TO: T10 SBP-3 working group

RE: Multi-processor enhancements to FAST_START

This document is a revision of the FAST_START enhancement proposal first suggest by David Wooten, next discussed at the Colorado Springs T10 meeting and subsequently described by Andy Green in 01-248r0. Most of the changes reflect editorial considerations in preparation for addition of the material to the SBP-3 working draft, but there are also minor technical changes.

Figure 46 – FAST_START format

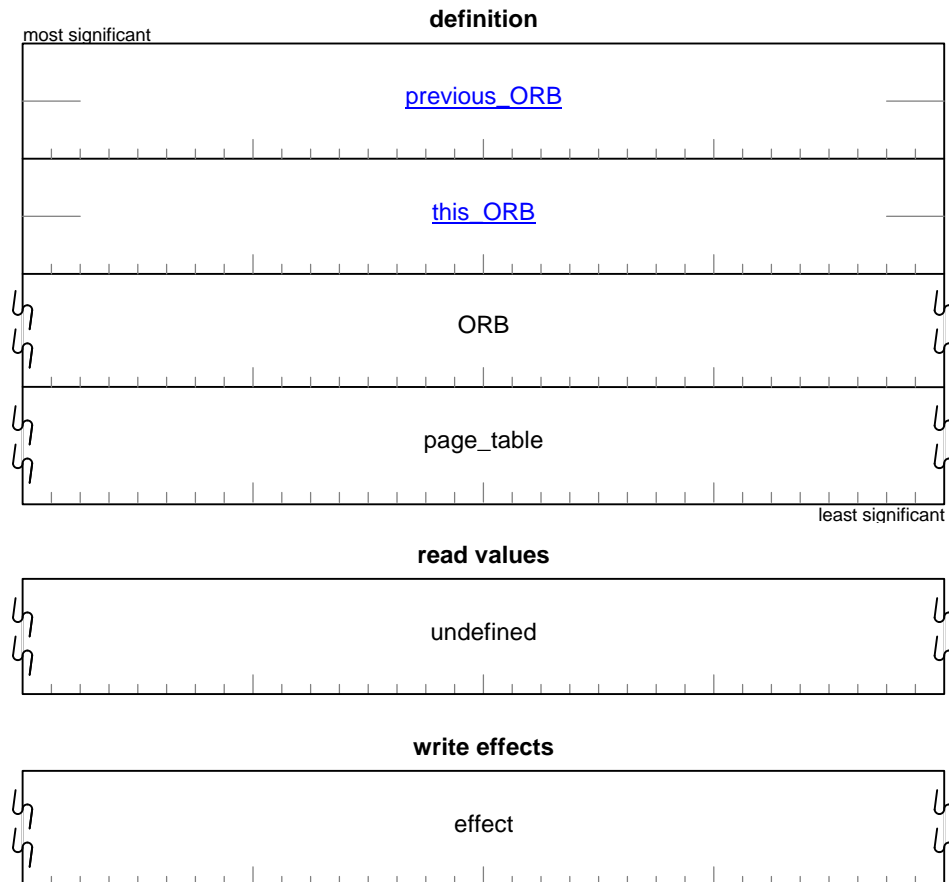
The [previous_ORB](#) field shall conform to the address pointer format illustrated by Figure 12 and shall either be a null pointer or reference an ORB in initiator memory whose *next_ORB* field is equal to the [this_ORB](#) field in the block write request addressed to the FAST_START register. When [previous_ORB](#) is not a null pointer, the ORB's Serial Bus address shall be formed from the concatenation of the 16-bit node ID of the initiator (available to the target as a result of login) and the [previous_ORB](#) field.

The ~~ORB_offset_hi~~ and ~~ORB_offset_lo~~ fields ~~together form an ORB_offset field which shall reference~~ [this_ORB](#) field shall conform to the address pointer format illustrated by Figure 12 and shall contain the [address of an ORB in](#) initiator memory whose contents are identical to the *ORB* field in the block write request addressed to the FAST_START register. The ~~corresponding ORB's~~ Serial Bus address shall be formed from the concatenation of the 16-bit node ID of the initiator (available to the target as a result of login) and the ~~ORB_offset~~ [this_ORB](#) field ~~and two least significant bits of zero~~.

The *ORB* field shall contain an ORB whose format conforms to those specified by 5.1. The length of the ORB is variable and shall be determined by the combination of *rq_fmt* and the type of fetch agent (normal or stream) associated with the FAST_START register. An initiator shall not address a block write request to the FAST_START register whose *data_length*, in bytes, is less than eight plus the size of the *ORB* field. The target shall reject a block write request addressed to the FAST_START register if its *data_length*, in bytes, is less than ~~eight~~ sixteen plus the size of the *ORB* field.

The *page_table* field, if present, shall immediately follow the *ORB* field. If the format of the *ORB* field includes a nonzero *page_table_present* bit, the *page_table* field shall contain zero or more page table entries whose order and content shall be identical to those contained within the page table referenced by the *data_descriptor* field in the ORB referenced by ~~ORB_offset~~ this ORB. The *page_table* field may be a subset of the page table referenced by the ORB, but no partial page table entries shall be present (see 5.2). The target shall derive the number of immediately available page table entries from the *data_length* of the block write request addressed to the FAST_START. The number of page table entries is limited by the maximum size of the FAST_START register.

~~The *data_length* of block write requests addressed to the FAST_START register shall be a multiple of four.~~

Figure 68 – Fetch agent state machine

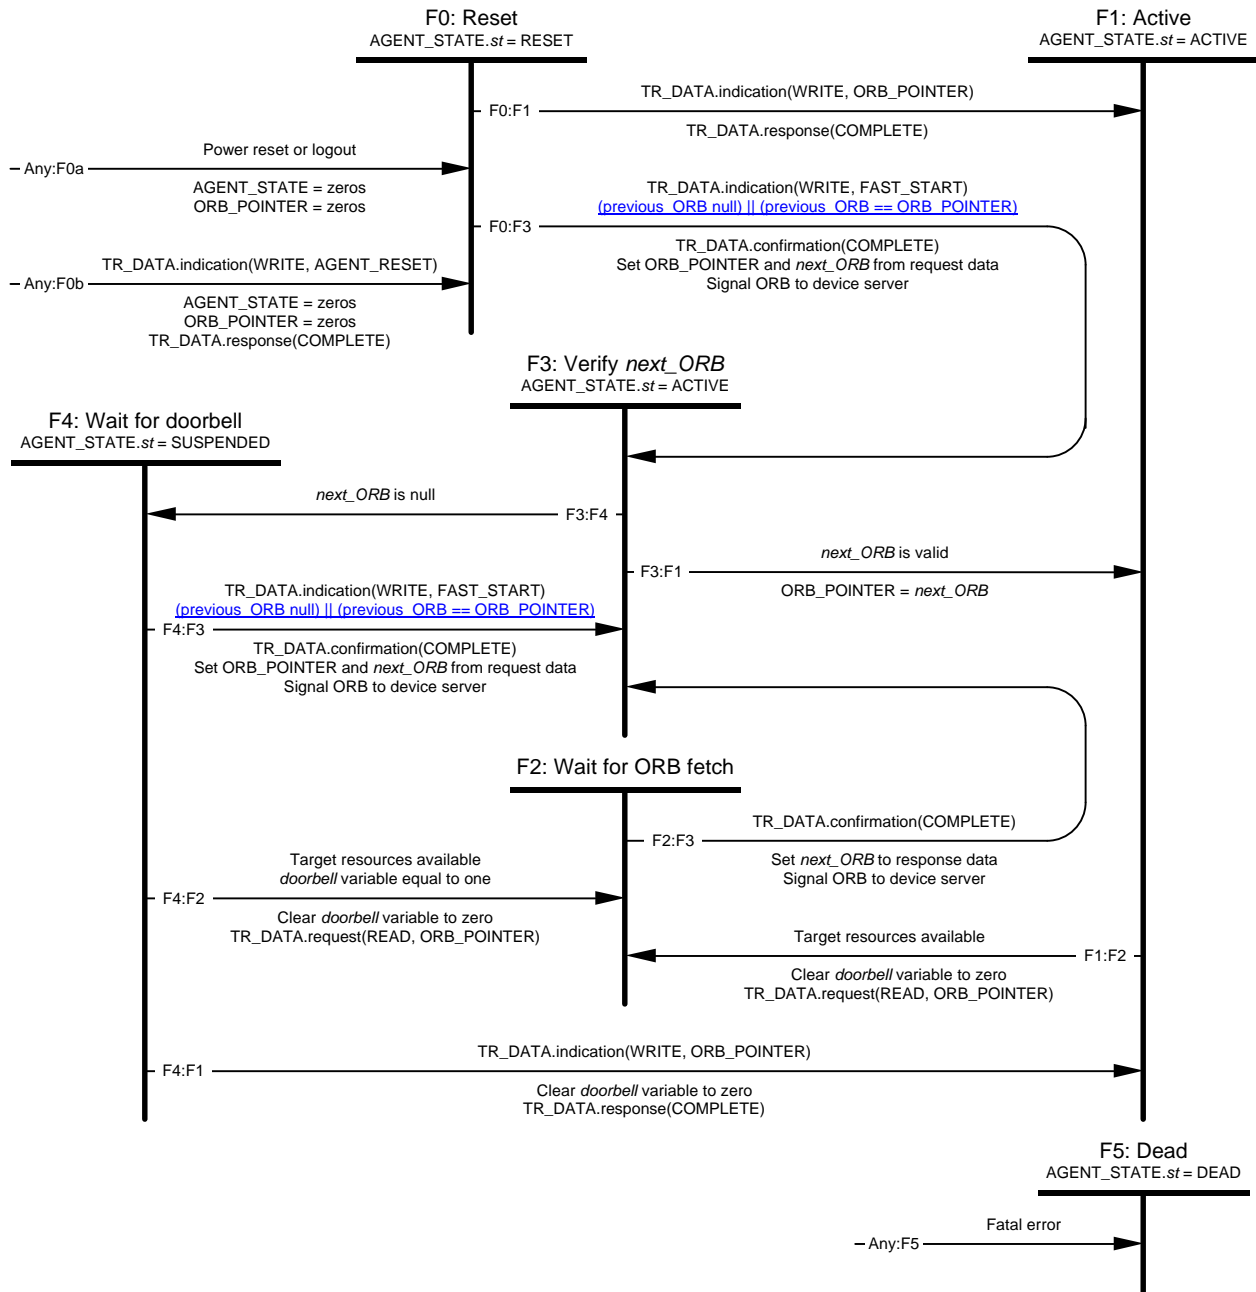
Transition F0:F3. A block write ~~of a valid *ORB_offset*, *ORB* and optional page table data~~ to the FAST_START register may affect the state of the fetch agent. If the *previous_ORB* field does not contain a null pointer and is not equal to the ORB_POINTER register, the fetch agent state shall not change and the target shall confirm the block write request with a response subaction of COMPLETE. Otherwise the fetch agent shall update the ORB_POINTER register with the value of ~~*ORB_offset*~~this *ORB*, shall update the *next_ORB* variable with the contents of the *next_ORB* field from the ORB contained within the block write request and shall cause the fetch agent to transition to state F3. The fetch agent shall also make the ORB and any page table data available to the device server for execution. Once these actions are complete, the target shall confirm the block write request with a response subaction of COMPLETE.

NOTE – If the *previous_ORB* field is either null or equal to the ORB_POINTER register, a target may interpret a block write addressed to its FAST_START register as if the ~~first eight bytes~~ this *ORB* field had been written to its ORB_POINTER register. Although it is less efficient to elect transition F0:F1, it is functionally equivalent to transition F0:F3.

Transition F4:F3. A block write ~~of a valid ORB_offset, ORB and optional page table data~~ to the FAST_START register may affect the state of the fetch agent. If the *previous_ORB* field does not contain a null pointer and is not equal to the ORB_POINTER register, the fetch agent state shall not change and the target shall confirm the block write request with a response subaction of COMPLETE. Otherwise the fetch agent shall update the ORB_POINTER register with the value of ~~ORB_offset~~ *this_ORB*, shall update the *next_ORB* variable with the contents of the *next_ORB* field from the ORB contained within the block write request and shall cause the fetch agent to transition to state F3. The fetch agent shall also make the ORB and any page table data available to the device server for execution. Once these actions are complete, the target shall confirm the block write request with a response subaction of COMPLETE.

NOTE – If the *previous_ORB* field is either null or equal to the ORB_POINTER register, a target may interpret a block write addressed to its FAST_START register as if the ~~first eight bytes~~ *this_ORB* field had been written to its ORB_POINTER register. Although it is less efficient to elect transition F4:F1, it is functionally equivalent to transition F4:F3.
